CITY OF
West Linn
 PLANNING AND DEVELOPMENT

PLANNING DIRECTOR DECISION

FILE NO.: DR-12-12

REQUEST: Class I Design Review for the proposed reconfiguration of parking lots and their access points at West Linn High School, 5290/5464/5515/5527/5599/5701 West A Street

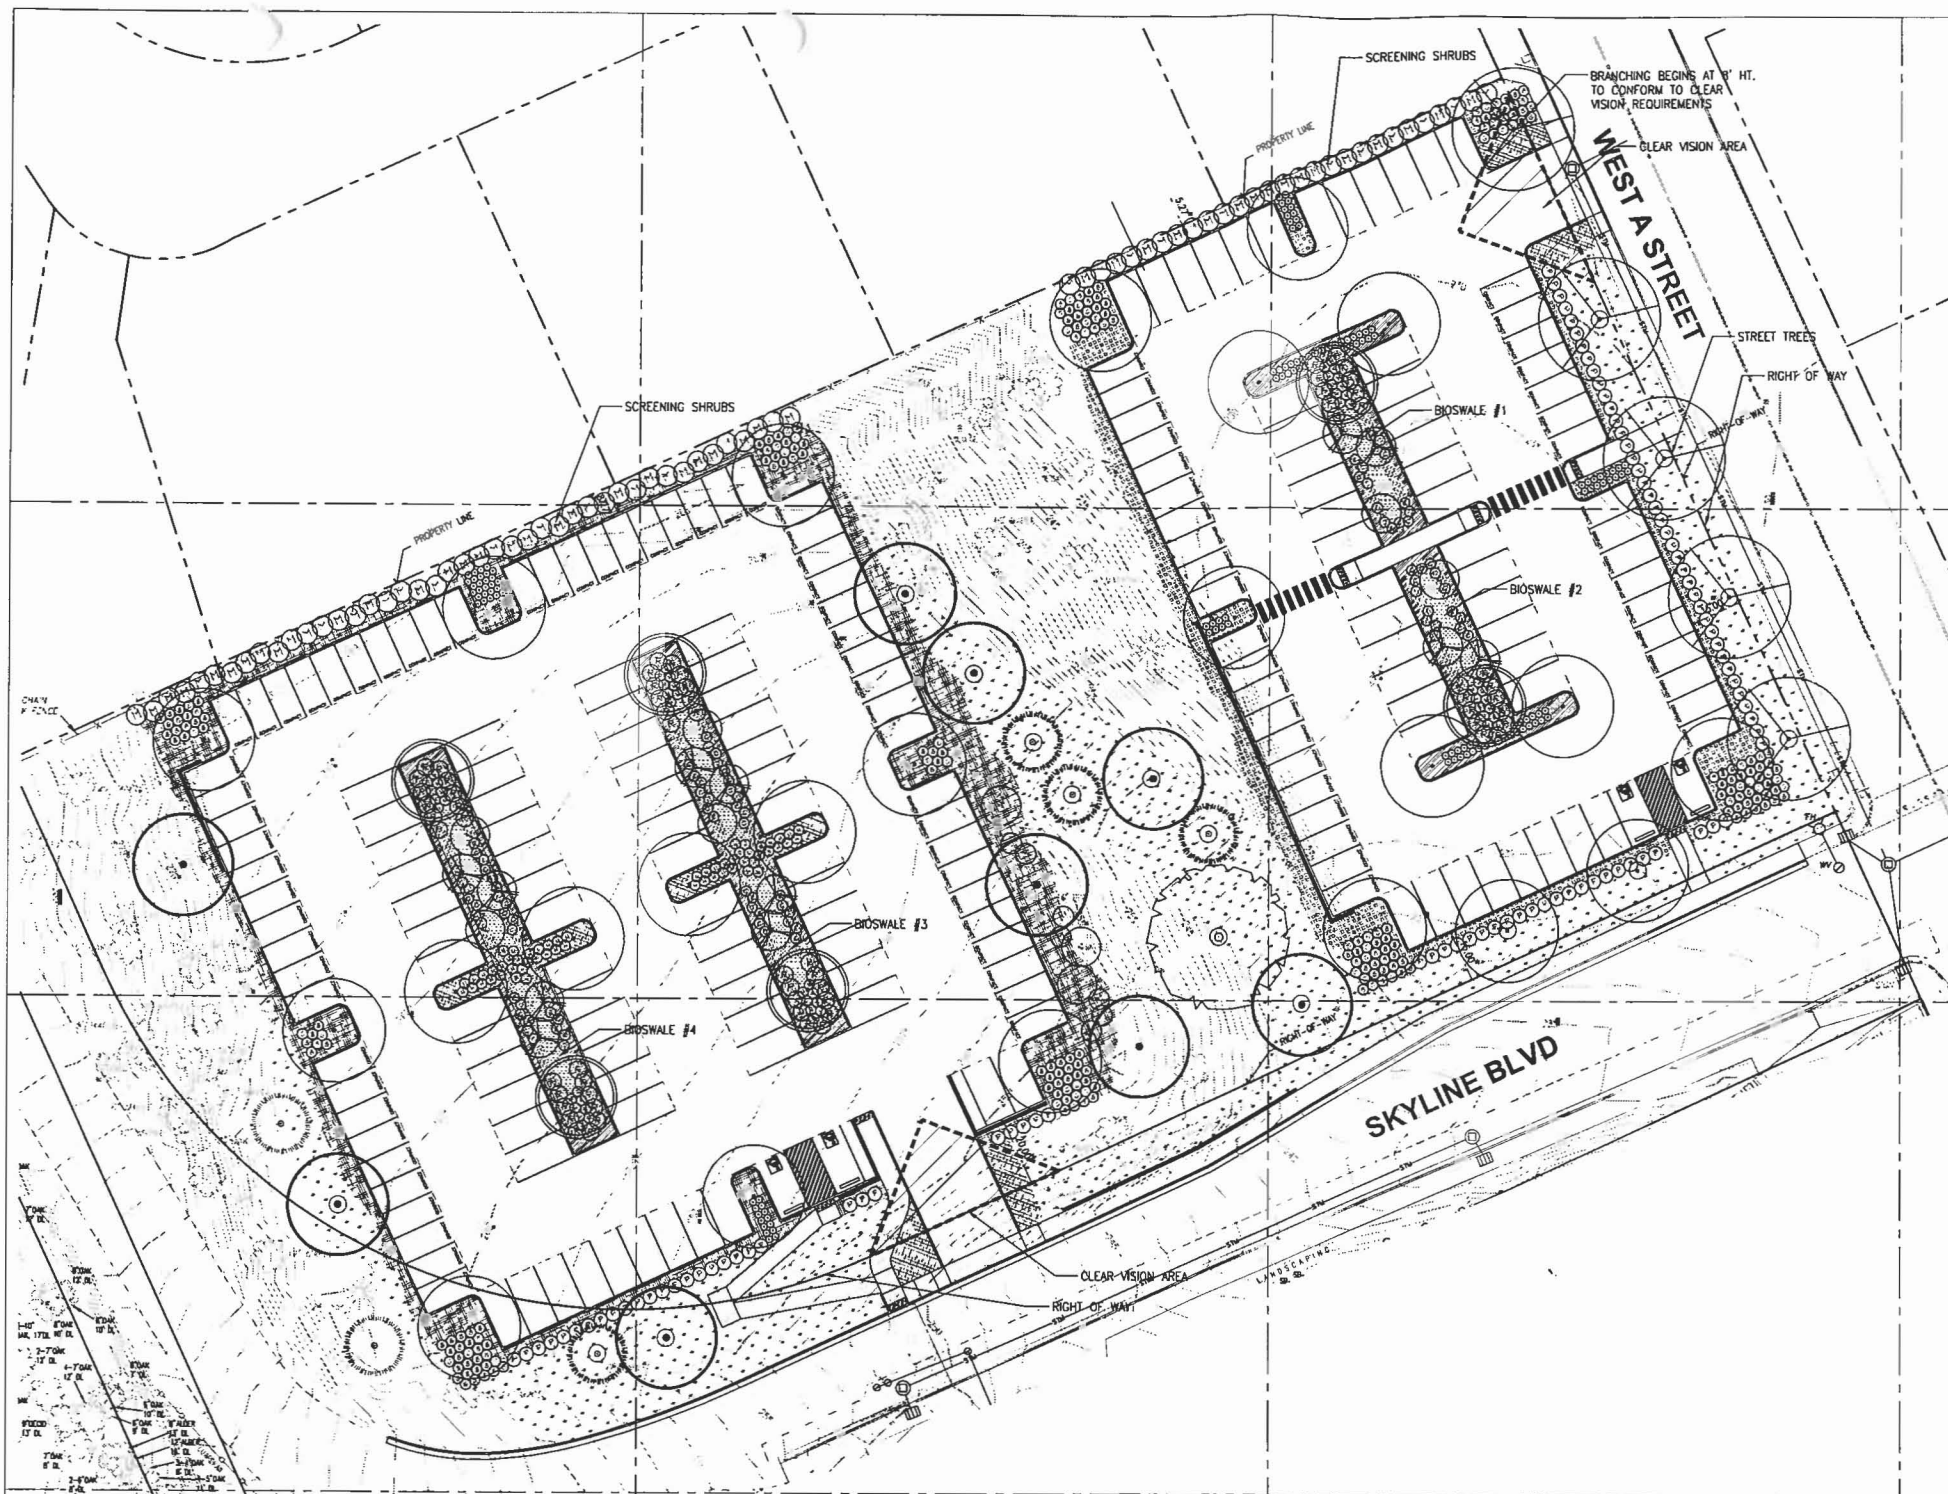
Native species are proposed. Western Serviceberry is proposed on the Planting Plan under “trees” but the City Arborist considers it to be a shrub and does not consider it to be fruit bearing, so the trees proposed meet the criteria above.

At the northeast corner, the applicant proposes 24 shrubs of the species little princess spirea. The Planting Plan notes that these have branching that begins 8 feet above the ground, which is appropriate as some of these are the planted in the required clear vision triangles of Chapter 42. The applicant used the clear vision triangle provided by Section 42.050 for the Planting Plan rather than that provided by Section 42.040. The triangle dimensions provided by Section 42.040 is required for intersections with driveways of 24 feet in width, such as these. Also, the triangle provided by 42.040 is required at the intersection of the two street right-of-ways. This required triangle is measured 30 feet back from the edge of each right-of-way at the intersection of West A Street and Skyline Drive. For the intersection of the streets with the proposed parking lot driveways, it is measured 30 feet back from the street right-of-way line and 30 feet back from the edge of each proposed driveway.

A total of two street trees, and several of the laurel and mock orange, are proposed within these triangles. Condition of Approval 2(a) requires only species of trees and shrubs that will not have branches, leaves, and flowers between 3 and 8 feet above the ground be planted here, in order to meet the provisions of Chapter 42 Clear Vision Areas.

2. Landscaping.
 - a. Planting in Clear Vision Areas. Within the clear vision triangles required by Section 42.040 for the intersections of the right-of-ways, and for the intersection of the driveways with the right -of -ways, the proposed street tree and shrubbery planting locations shall be planted only with street trees and shrubs that will not have branching, leaves, or flowers between 3 feet and 8 feet off the ground. The number of proposed street trees shall not change. The proposed shrubbery shall still screen the off-site areas they are currently proposed to screen, except in the general area 3-8 feet off the ground within the clear vision triangles. The species of trees and shrubs used to meet this condition shall be approved by the City Arborist.

- b. Irrigation System for Proposed Plantings. The applicant shall install an irrigation system, to the satisfaction of the City Arborist, that is appropriate for the long-term maintenance of the proposed plant species.

- c. New Planting Plan. The applicant shall submit to staff a new planting plan complying with conditions 2a and 2b.
3. Sidewalk width. The proposed sidewalks extending between the streets and the parking lots shall be 8 feet wide along the segments where they abut driveways and/or parking spaces. The proposed retaining wall along the west parking lot's sidewalk shall be moved 2 feet to the west to accommodate this widening.
